## Network Video Recorder

**Version: V4.32.110 build211009**

### Release Note

## 2. 【Added privacy prompts on GUI and web activation and login interface】

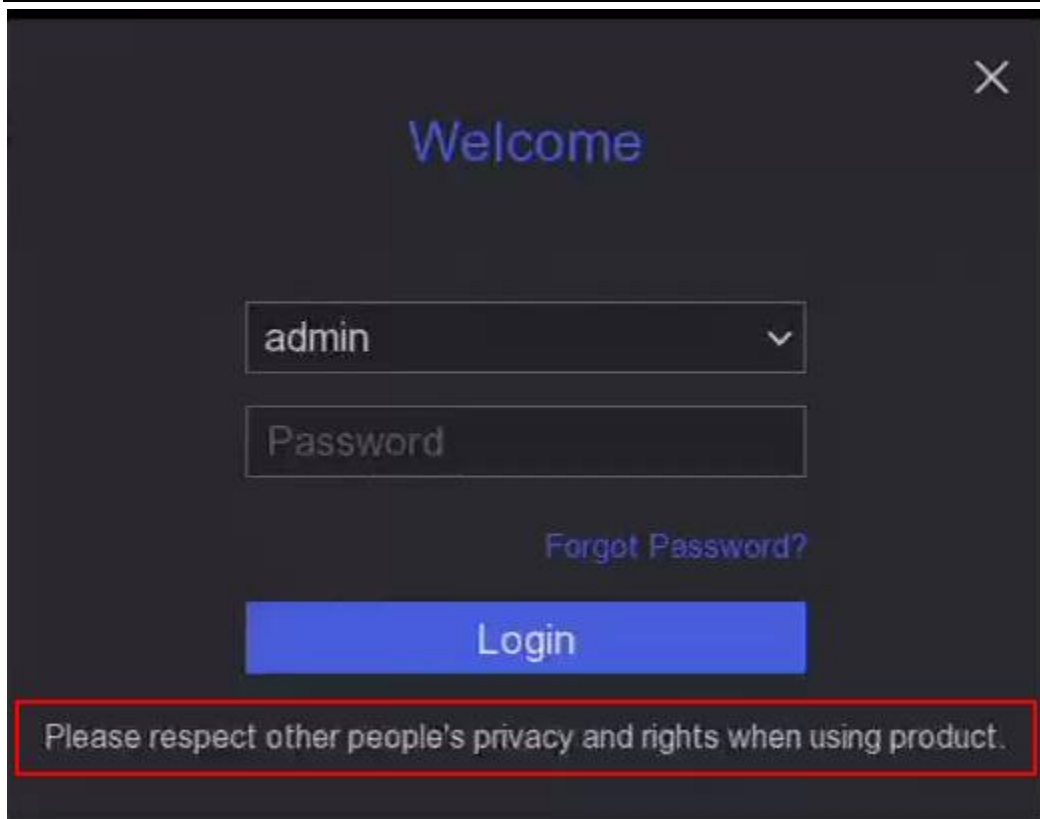
### 1) GUI

2) Web
